PROJECT: iMX31-10	
PART NUMBER: 1004734	
ASSEMBLY NAMEiMX31-10 SOM	
SCHEMATICS: KTL,NJK	
TABLE OF CONTENTS	
PAGE	DESCRIPTION
1	TITLE PAGE AND BLOCK DIAGRAM
2	CONNECTORS
3	WEIM BUS BUFFERS
4	MX31/DDR RAM
5	FLASH
6	WIRED LAN
7	LOGIC/ADC
8	MX31/UARTS/CODEC
9	MX31/CSI/KEYPAD/USB PHYS
10	MX31/LCD/JTAG/SD1
11	MX31/ATLAS POWER
12	MX31/RST/BOOT/NF/PCMCIA
13	TESTPOINTS
14	ECO LIST

Title iMX31 LV-SOM		Project MX31-10
Number 1004734	Rev 11	Sheet 4 Of 14

02 - EXPANSION BUS

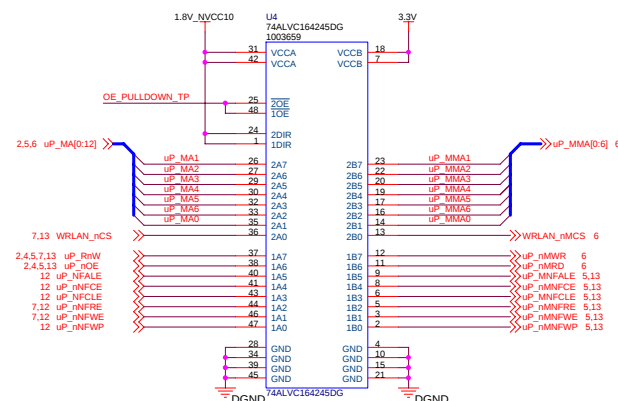
REVISION 2 -> 3
1) CHANGED U4 PIN 36 FROM uP⁻MA7 TO uP⁻MA0.
2) CHANGED U4 PIN 13 FROM uP⁻MMA7 TO uP⁻MMA0

REVISION 2 -> 3
1) CHANGED U4 PIN 36 FROM uP⁻MA7 TO uP⁻MA0.
2) CHANGED U4 PIN 13 FROM uP⁻MMA7 TO uP⁻MMA0

04 - DDR RAM

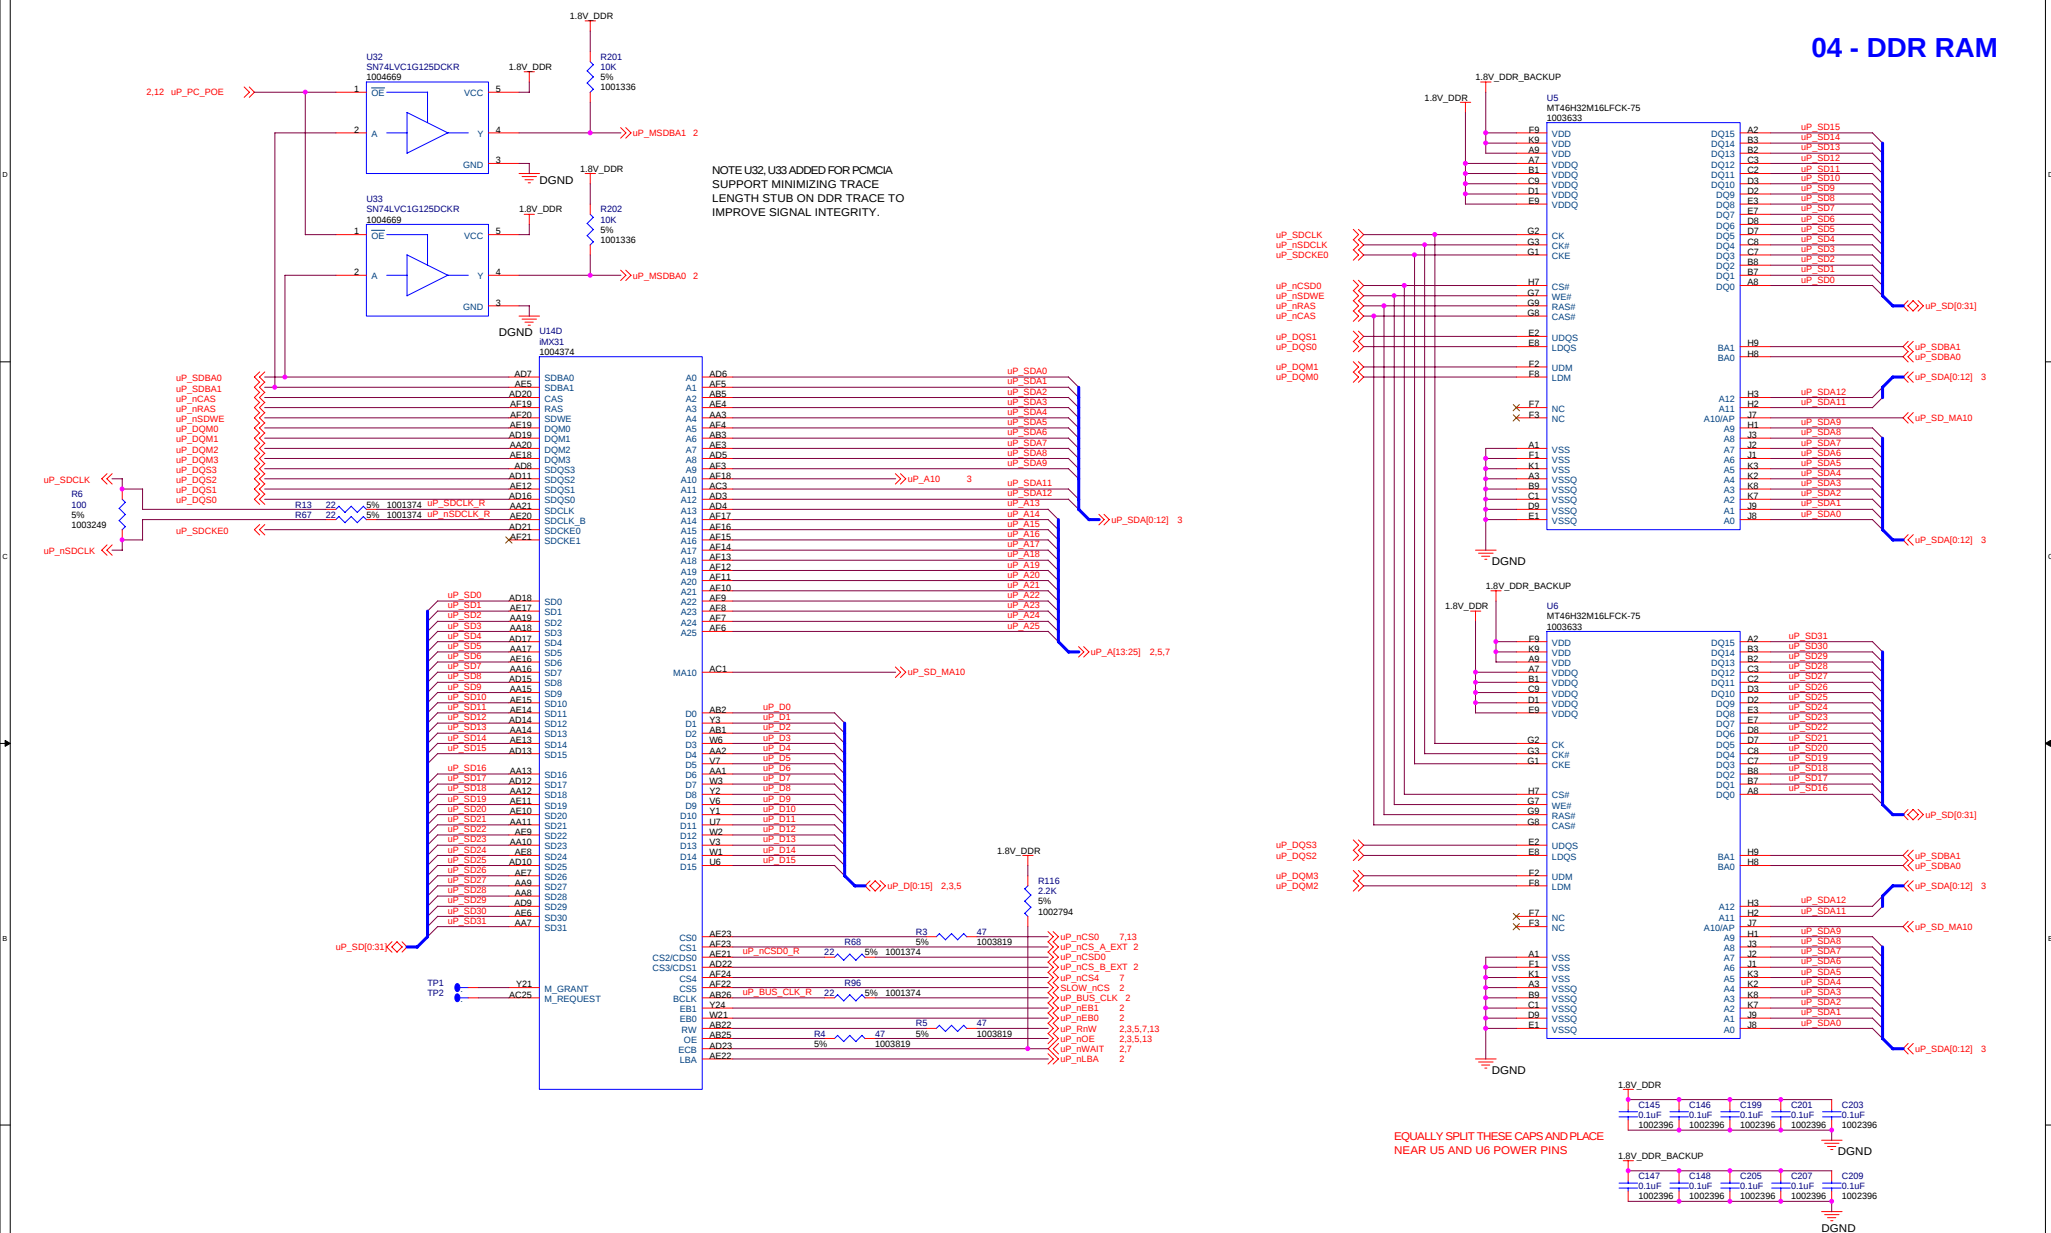
REVISION 5 -> 6
1) REMOVED C253, C254, C200, C202, C204, C206, C208-210
2) ADDED R6

REVISION 4 -> 5
1) ADDED R201 AND R202
2) CHANGED OE ON U32 AND U33 TO BE CONTROLLED BY uP_PC_POE

REVISION 3 -> 4
1) CHANGED U38, U39 TO U32, U33 ACTIVE LOW
SINGLE BIT BUFFERS

05 - FLASH

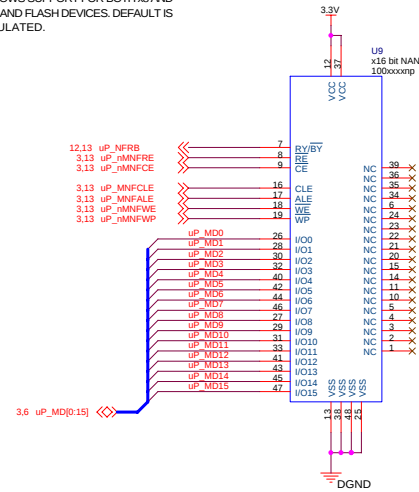
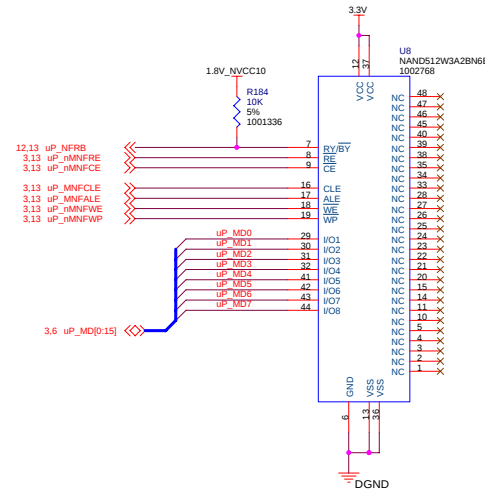
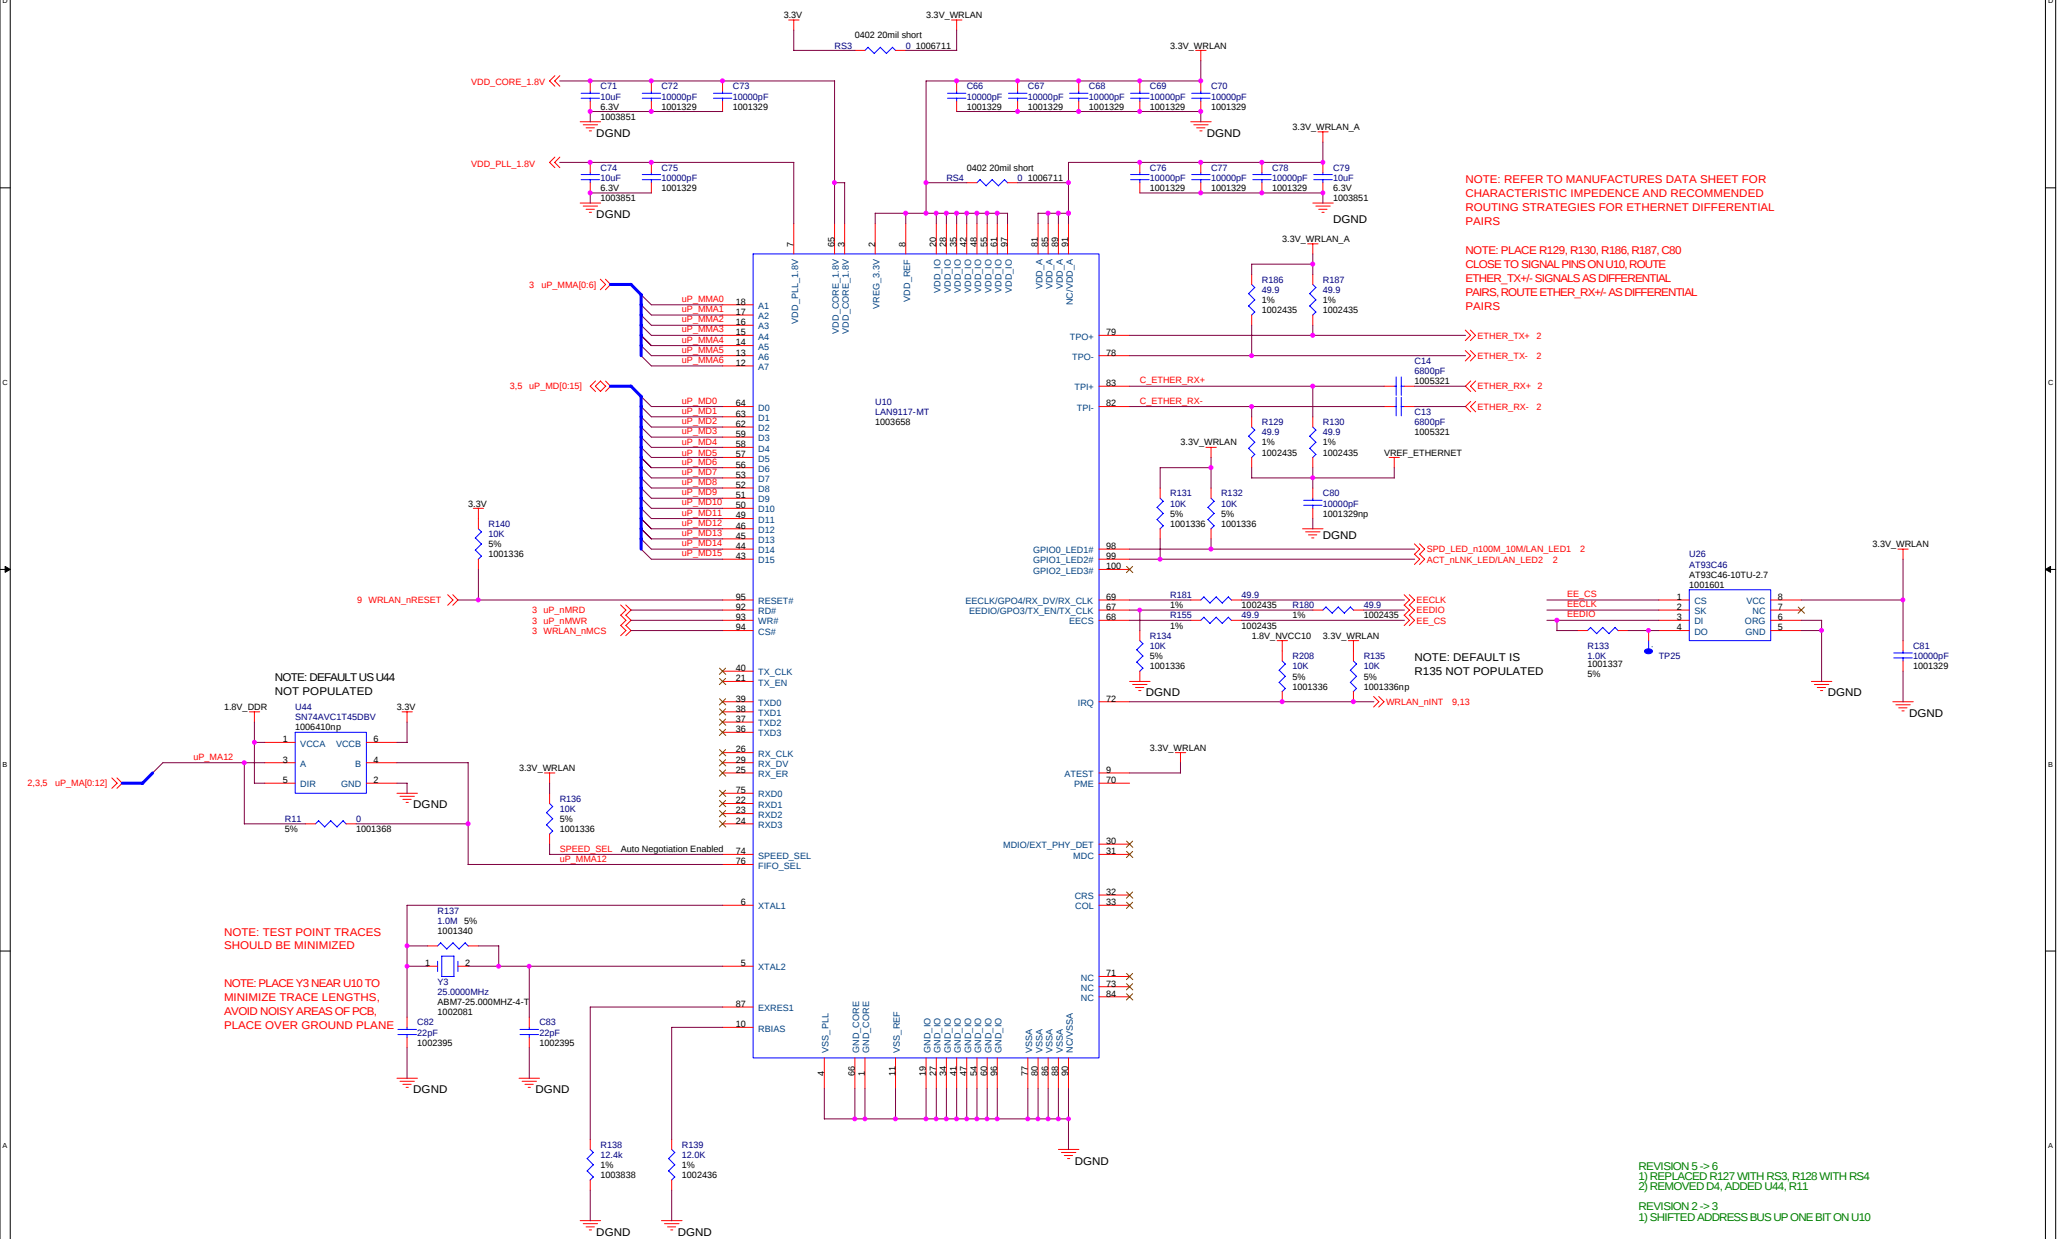
REVISION 2 -> 3
1) SHIFTED ADDRESS BUS UP ONE BIT ON U7

06 - WIRED LAN

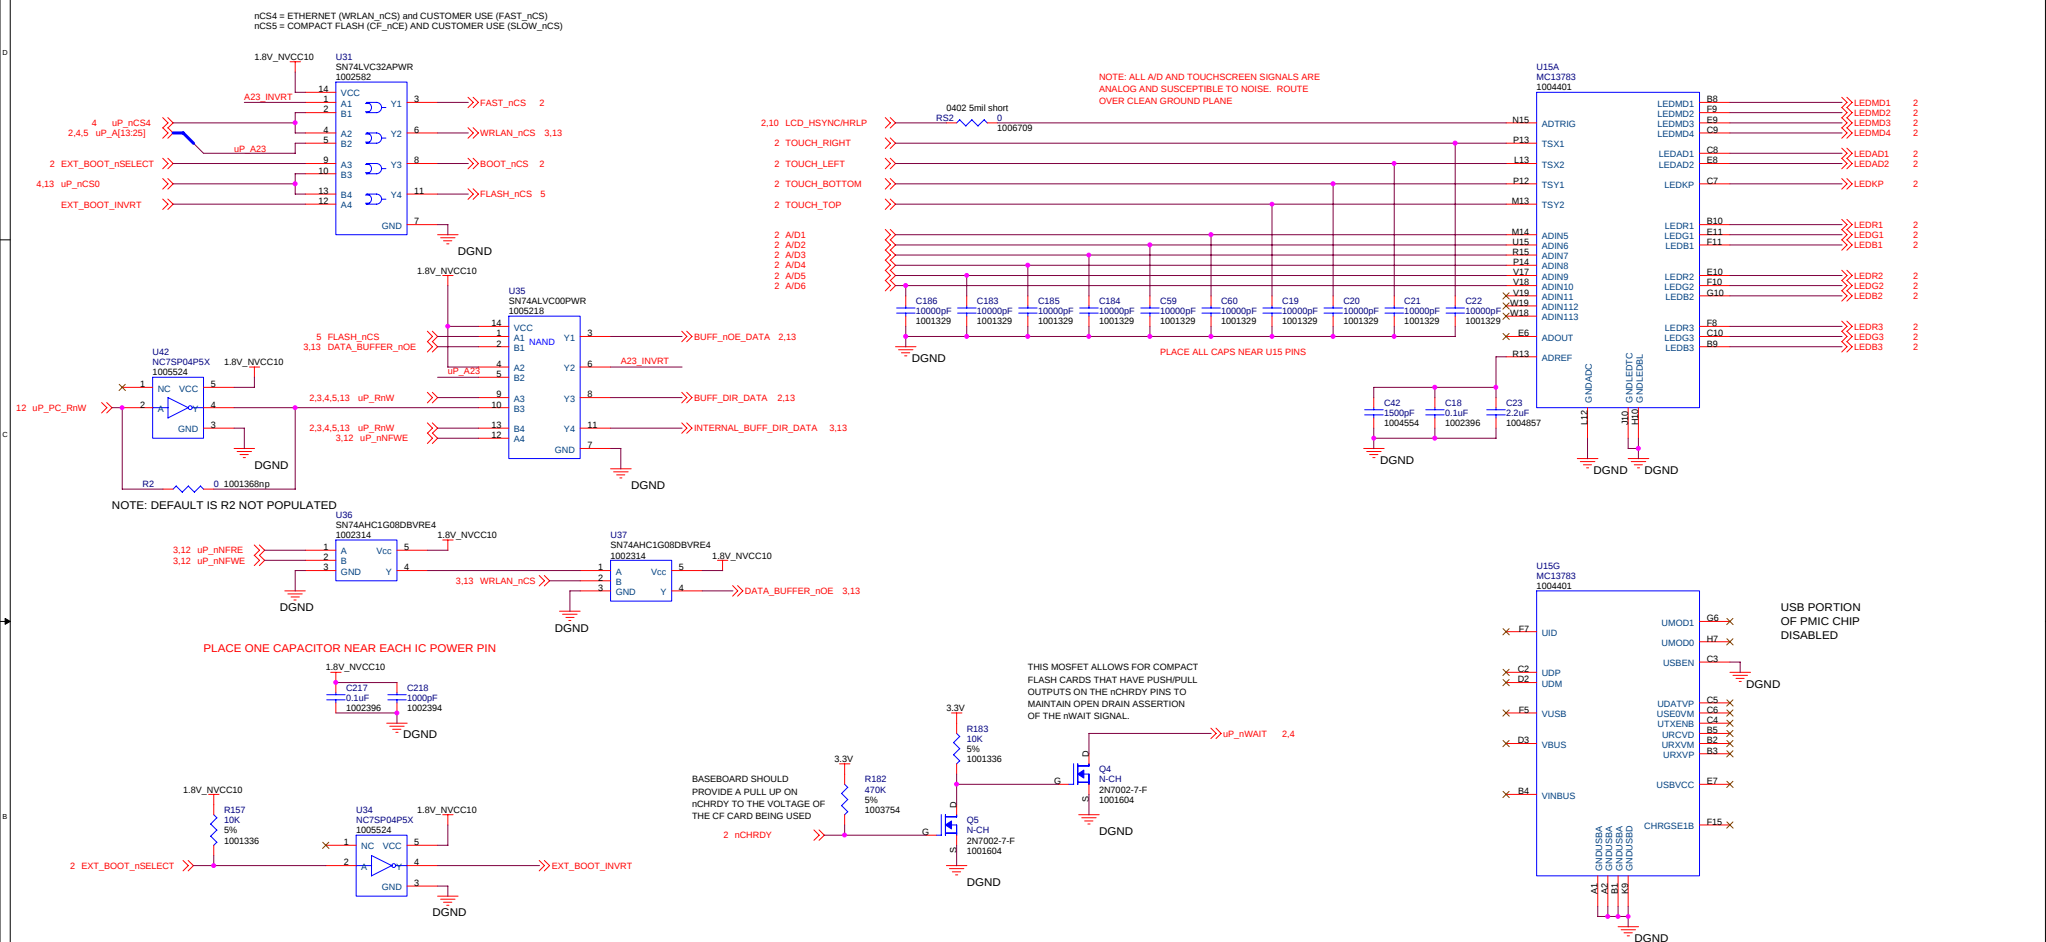
REVISION 5 -> 6
1) REPLACED R127 WITH RS3, R128 WITH RS4
2) REMOVED D4, ADDED U44, R11

REVISION 2 -> 3
1) SHIFTED ADDRESS BUS UP ONE BIT ON U10

07 - LOGIC/ADC

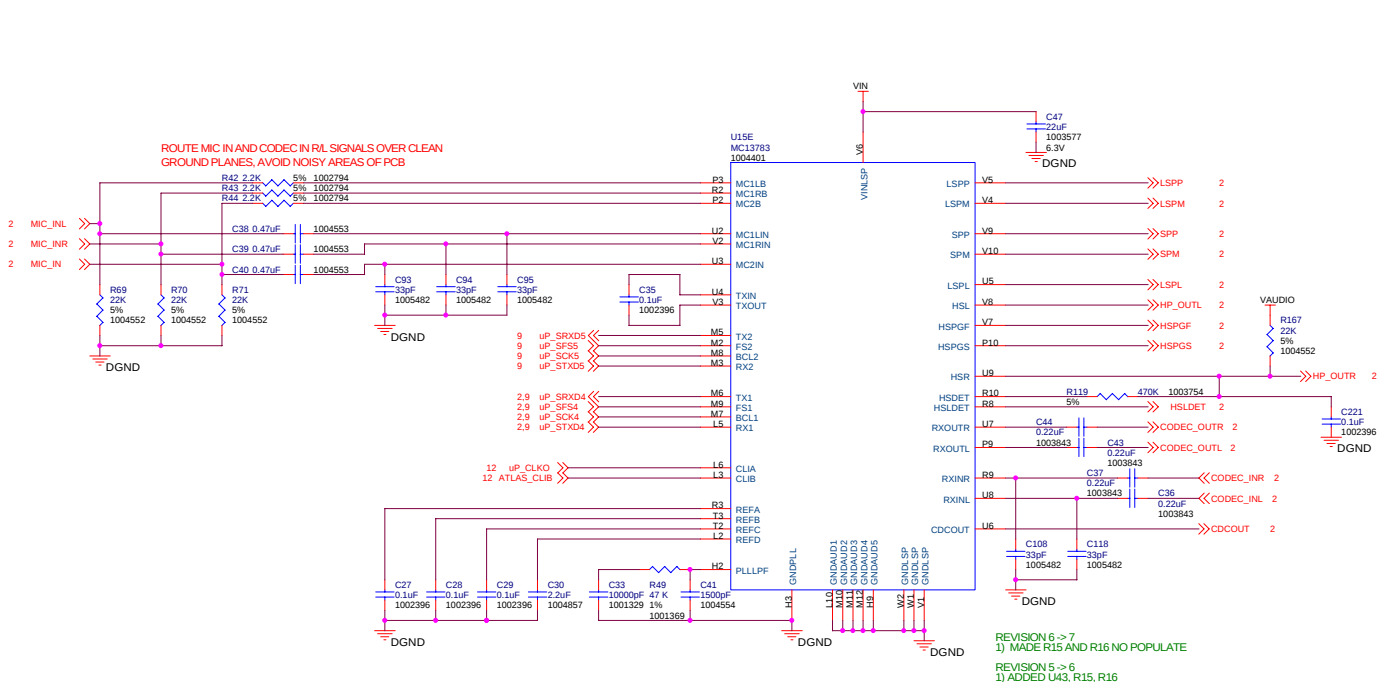
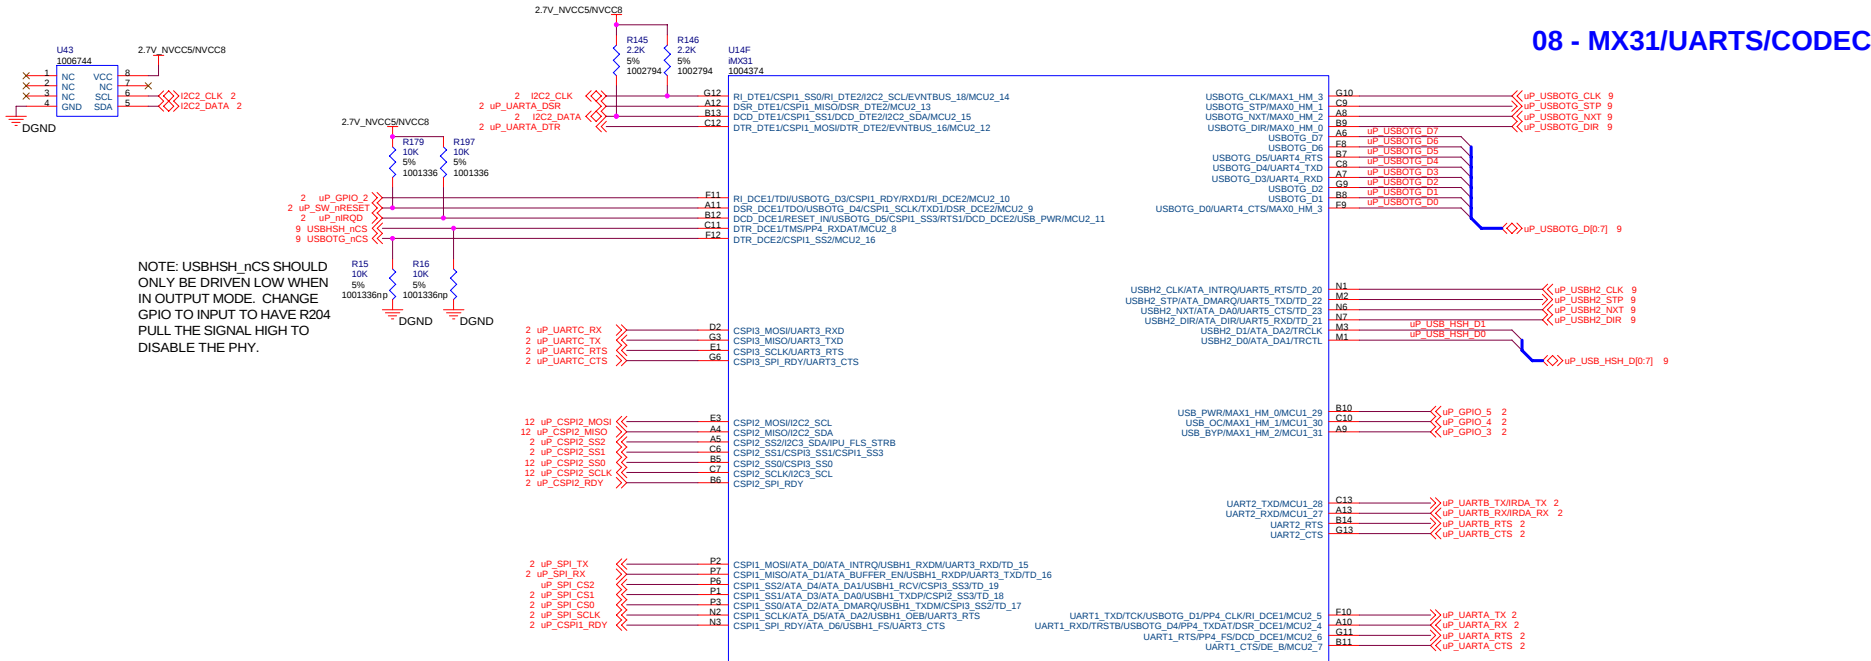
REVISION 5 -> 6
1) REMOVED C251
2) ADDED U42, PADS FOR R2
3) REPLACED R35 WITH RS2
4) SWAPPED X AND Y TOUCH SIGNAL GROUPS,
SWAPPED X INPUTS.

REVISION 3 -> 4
1) CHANGED U35 PIN 12 INPUT FROM $\overline{uP_nRnF}$ TO $\overline{uP_nRnWE}$
2) CHANGED TO A23 FOR ADDRESS CONTROL LINE
FOR DIFFERENT MEMORY AREAS
3) CHANGED U35 PIN 13 TO $\overline{uP_RnW}$
4) DROPPED SUPPORT CF_ $\overline{nCE}$ SIGNAL, ADDED
EXTERNAL NOR BOOT OPTION
5) CHANGED U34 FROM BUFFER (INCORRECT PART) TO INVERTER
